LINCOLN & DRANSFELDT

WATER AND SANITARY PLANS

ISSUE DATE: 08-16-2021	PROJECT #: 200829
DATE	REVISION COMMENTS
11-17-2021	PER PWSD COMMENTS

LINCOLN & DRANSFELDT
SANITARY PLAN & PROFILE

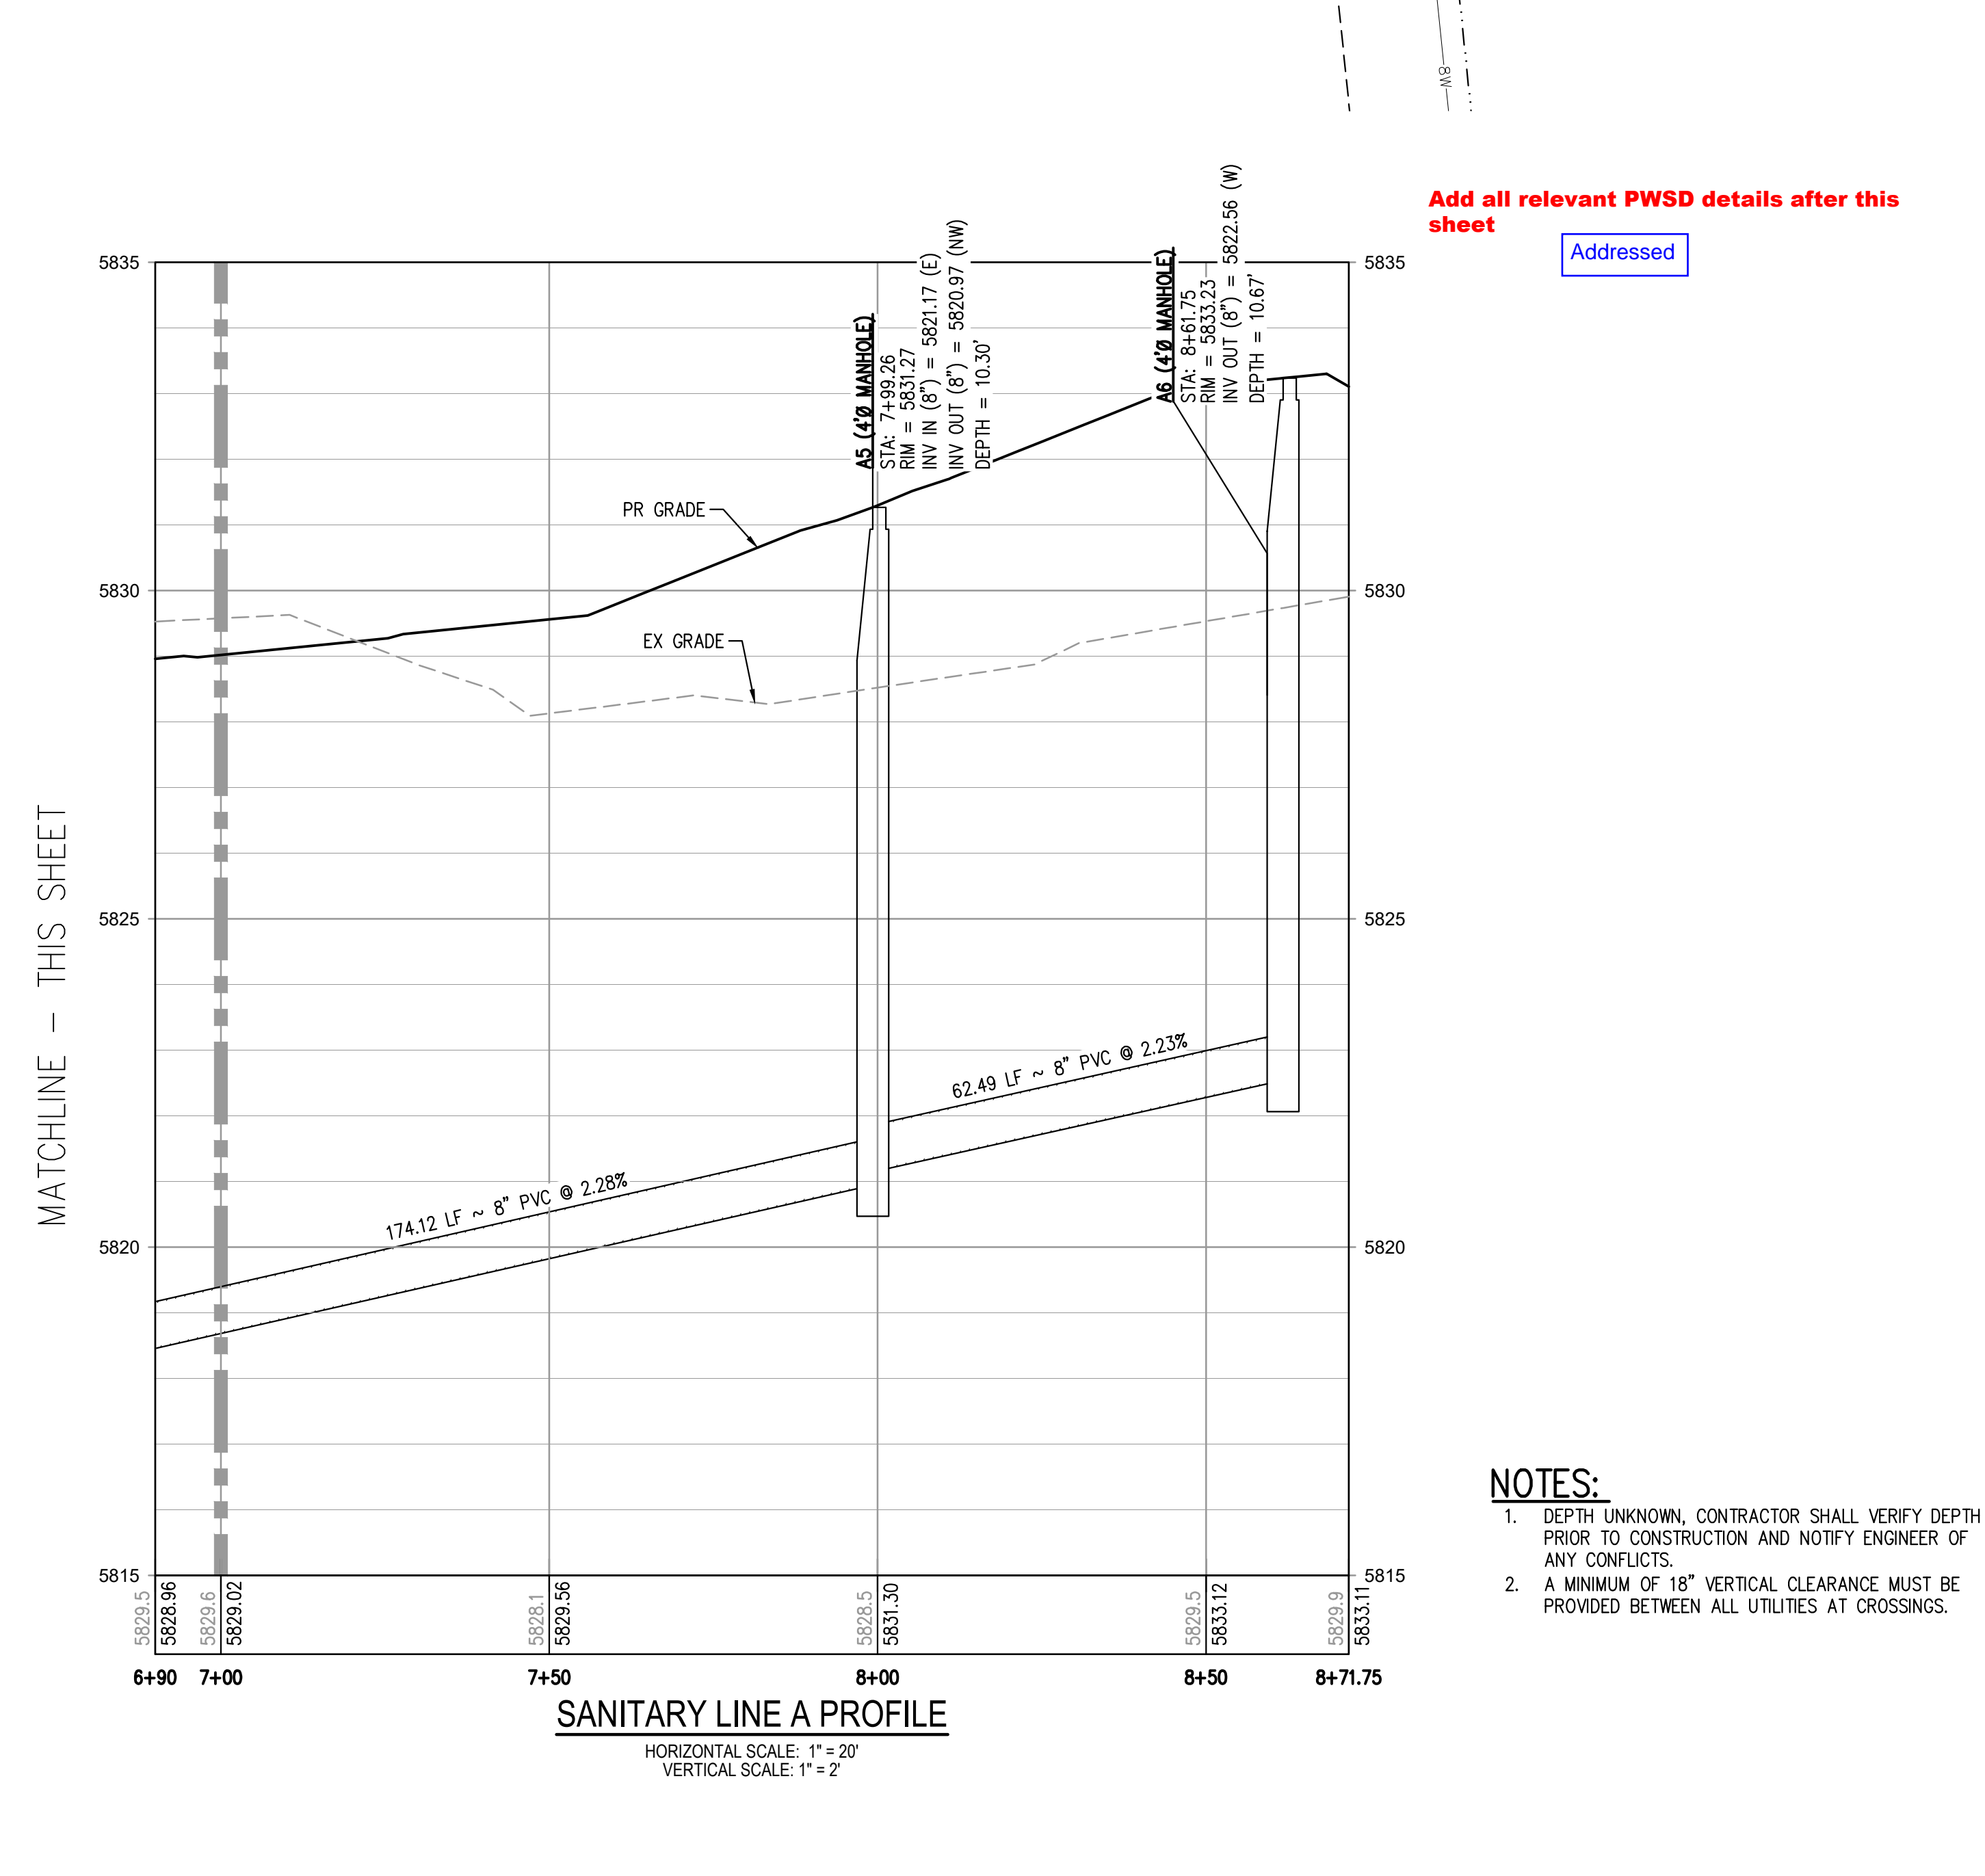
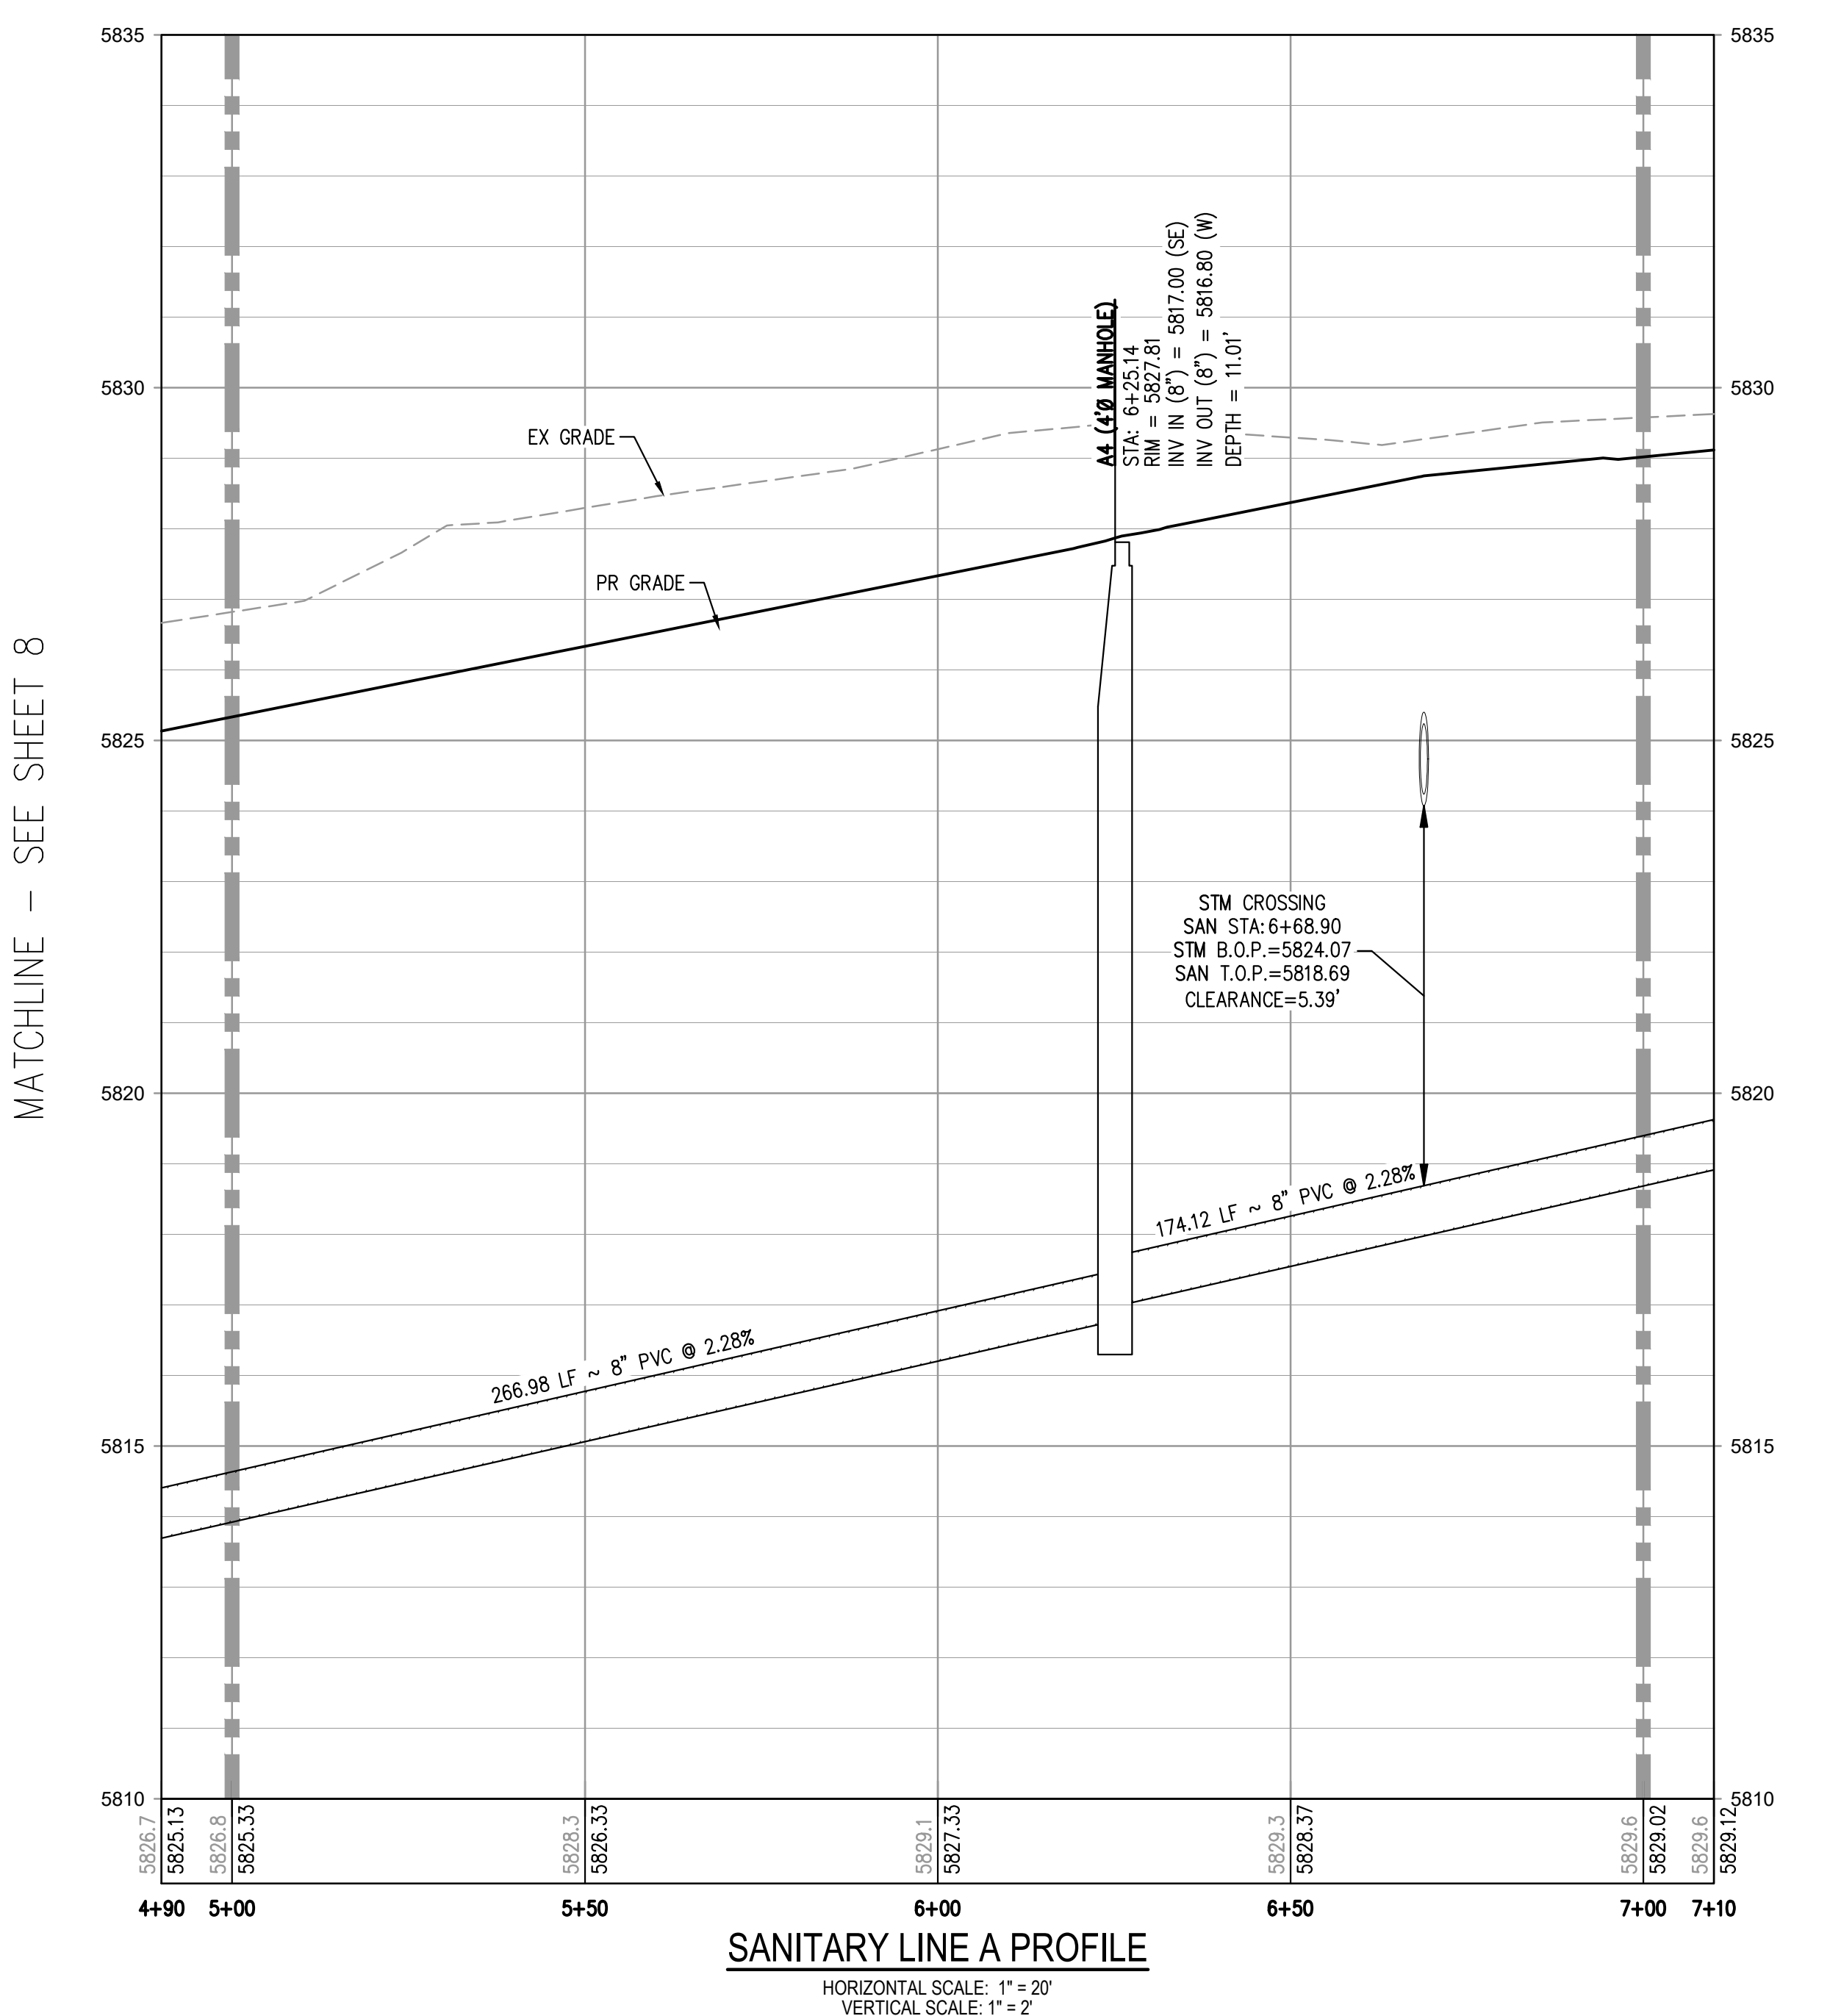
Add all relevant PWSD details after this sheet
Addressed
